UL 9540A DATA UTILIZATION GUIDE FOR NYC: FLOW CHARTS

This ***UL 9540A Data Utilization Guide for NYC: Flow Charts*** document is intended as a supplement to the Outdoor Permitting Guide. It provides high-level guidance on the utilization of data obtained from ***UL 9540A, Test Method for Evaluating Thermal Runaway Fire Propagation in Battery Energy Storage Systems***, which is a key component of all lithium-ion based energy storage permitting applications under consideration by NYC AHJs. This document is built around the generic analysis flow charts included in the 4th Edition of the UL 9540A Test Method, annotating the critical data points, input assumptions, and analysis and documentation processes required to submit a compliant application specific to NYC. Future iterations are expected to provide additional guidance that delves into the details of the engineering analysis and AHJ acceptance criteria.

FIGURE 4

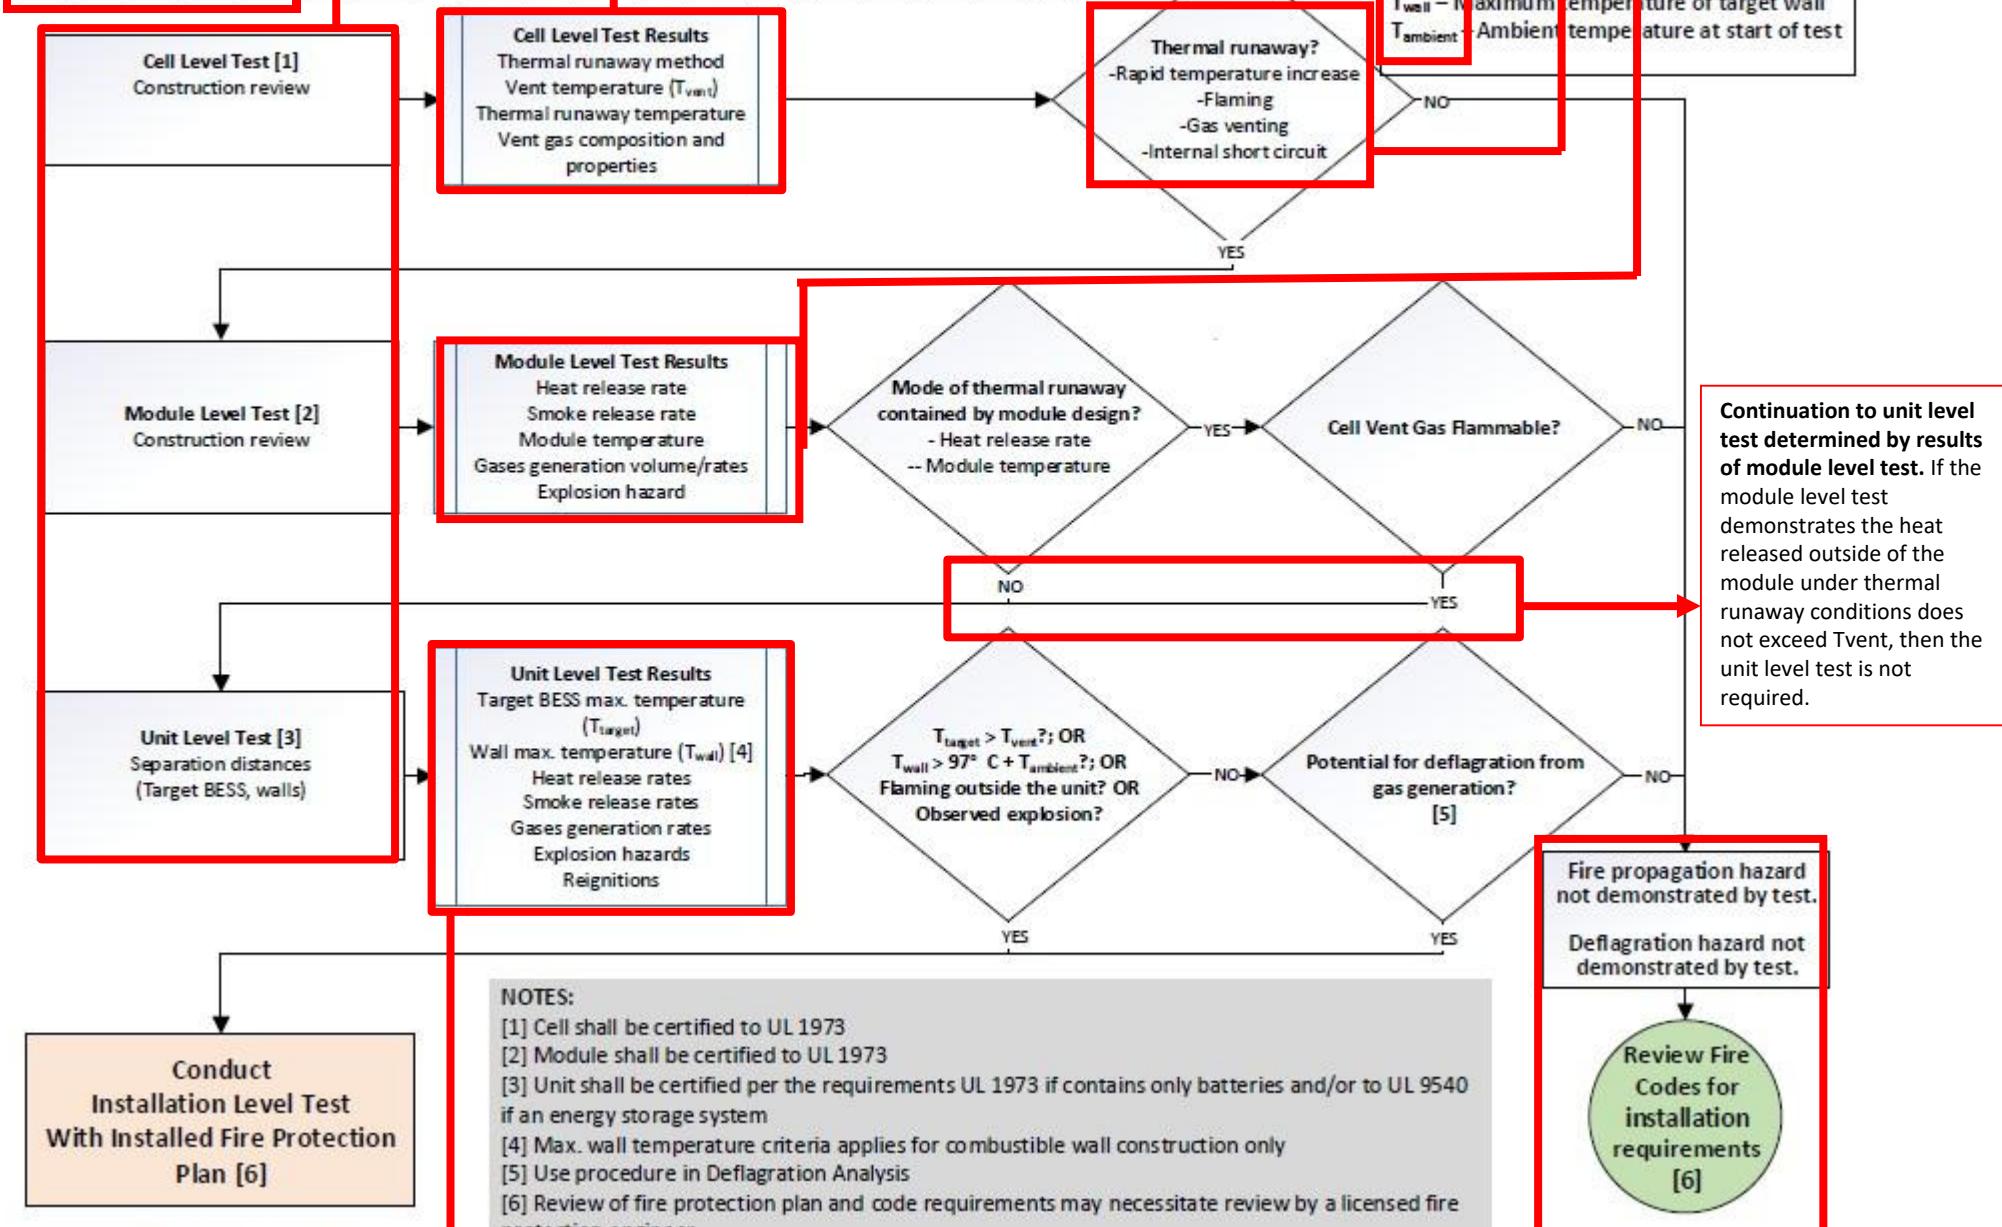
3, 5. Reporting requirements

Any submitted UL 9540A test report must include the following:

- Executive summary
- Laboratory
- Date of test
- Edition of test method
- Description of energy storage equipment
- Description of layout and mitigative systems
- Description of test set up
- Summary of results, in numeric and graphic format

Although not required as part of the test report submission, if during the course of the Authority's review additional information is needed, the full set of raw test data must be provided.

8. Toxicity analysis/modeling is not required for outdoor sites. Appropriate PPE should be identified for first responders, and prescriptive egress requirements must be followed. Indoor sites may require gas detection.

1. No exceptions will be granted for this test. A cell's ability to resist thermal runaway is not an acceptable reason to not perform the test, as external factors may impact the system which are not possible for internal controls to manage. As such, it is critical to understand if failure of the cell does occur, what the impact is.

4. As such, all projects must be submitted with a full UL 9540 test report and associated analysis OR submitted within a year of issuance of LONO/conditional acceptance letter.

2. FDNY and DOB will accept test results from any lab which is accredited to conduct UL 9540 or UL 1973. This is a temporary measure, as no laboratory can currently be accredited for the test method. This requirement is intended to prevent unqualified labs from performing a complex and dangerous test, and expect otherwise qualified labs to self-select based on the necessary skill sets. Considering a six month limitation on this period (mid-2020).

9. UL 9540A^{3rd} edition is considered by FDNY and DOB to be applicable to all system types, sizes, and installation locations. It is understood that newer UL 9540A editions or related publications may more directly address such installations. Until that point, the data gathered in the 3rd edition methodology will still be required, and may be analyzed as appropriate to each installation.

31. Conservative criteria are assessed in order to account for edge cases. It is recognized that the temperature at which the cell vents is not the same as the thermal runaway temperature; however, as an early part of the thermal runaway event, if no mitigative actions are taken, it is taken as a conservative initiating temperature.

13. Module level measurements:

- Propagation of thermal runaway
- External flaming
- Locations of flame venting
- Flying debris
- Peak heat release rate (HRR)
- Re-ignitions
- Gas composition pre-flaming
- Gas composition post-flaming

14, 15, 16. Cell test measurements:

- Thermal runaway initiation method
- Cell surface temperature at gas venting
- Cell surface temperature at thermal runaway
- Gas volume
- Gas composition (CO, CO₂, H₂, total hydrocarbons)
- Lower flammability limit (LFL)
 - Determined through secondary test, via the method outlined in ASTM 918 or ASTM E681
- Deflagration pressure (P_{max})
 - Determined through secondary test, via the method outlined in EN 15967
- Burning velocity (cm/s)
 - Determined through secondary test, via the method outlined in ASHRAE 34 or ISO 817

13. Unit level test measurements:

- Test configuration
- Fire protection systems within unit
- Thermal runaway propagation
- External flaming
- Locations of flame venting
- Flying debris
- Peak HRR
- Re-ignitions
- Max. target BESS temperature
- Max. wall surface temperature
- Gas composition pre-flaming
- Gas composition post-flaming

11. Construction review requirements:

- Use of identical data to the system installed is not mandatory, as long as the 'worst case scenario' system is tested and used.
- Approved test lab may conduct a formal construction review, per its own internal standards, comparing and contrasting the tested and untested technologies. This report must be provided with the permitting submission.

- If the approved test lab determines that the technology under test is considered, comparatively, to represent the 'worst case design', i.e., that its energy density, construction, or components represent a greater threat than the compared technology, it may provide test data from the tested technology instead for use in design of mitigative systems.

- "Scaling down" results from the worst-case scenario data, rather than directly using the worst-case scenario data, must be demonstrated as appropriate through testing by an approved lab. Models and assumptions are not currently acceptable.

12. A site specific risk analysis is necessary, signed and stamped by a NYS PE, including:

- Identification of hazards
- Severity and likelihood assessment
- Modes and mitigations analysis
- Gap analysis

FIGURE 5

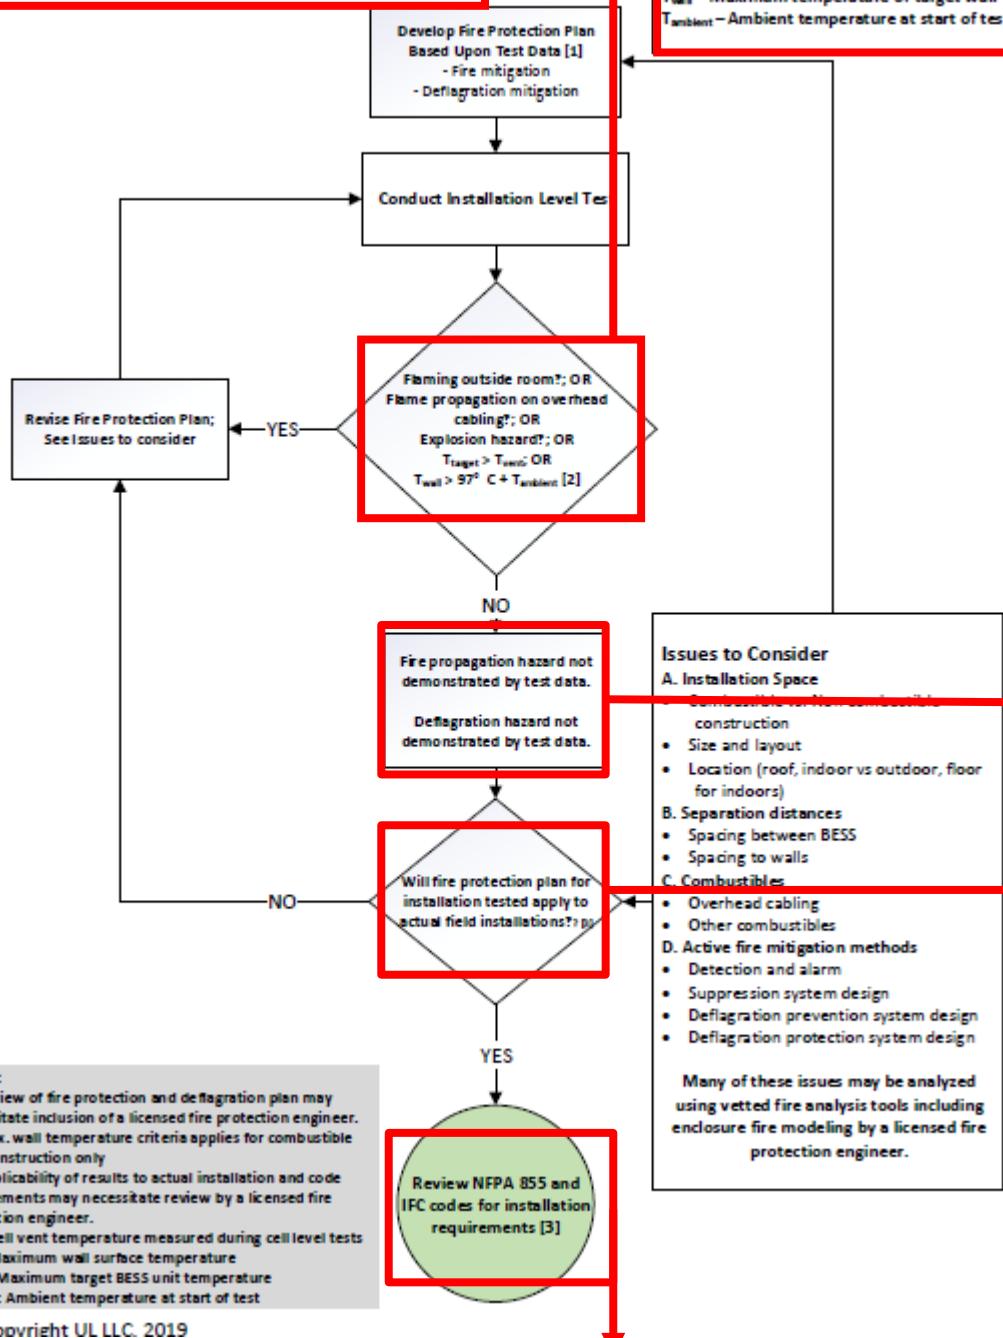
7. Reporting requirements

Any submitted fire spread analysis must include the following:

- Executive summary
- Methodology used (UL 9540A results or heat transfer calculations)
- Data input
- Result output
- Calculations and assumptions
- If model used, validation documentation
- Sign off on final design by NYS RA or PE

31, 33. Fire spread impact to neighboring batteries is tested. Spacing between battery racks is only determinable by testing aligned with UL 9540A (wherein temperature in adjacent unit reaches vent temp) through the unit level or installation level test.

7. Fire spread impact to neighboring exposures (e.g., buildings or walls, other equipment that is not batteries, and egress pathways or public ways) may be calculated or observed during the test. If calculated, the assessment may consider that fire rated or non-combustible surfaces may not be impacted by temperatures equal to ambient temperature + 97C.

27, 28. Fire threat should be assessed and documented by the NYS PE, but guidance for its definition and related minimum expectations include:

To buildings: The temperature at which the building will be affected beyond that deemed acceptable for the performance group (Ref: ICC 2009), with consideration for materials of and in building

To first responders: The heat flux at the fire department connection (FDC) should be demonstrated, through testing and analysis, as less than 2.5 kw/m² based on the proposed siting (Ref: SFPE Handbook). The FDC shall be in no case less than 10 ft from the system.

To bystanders: Egress pathways are determined through prescriptive requirements, with 10 ft of spacing required between system and egress pathway.
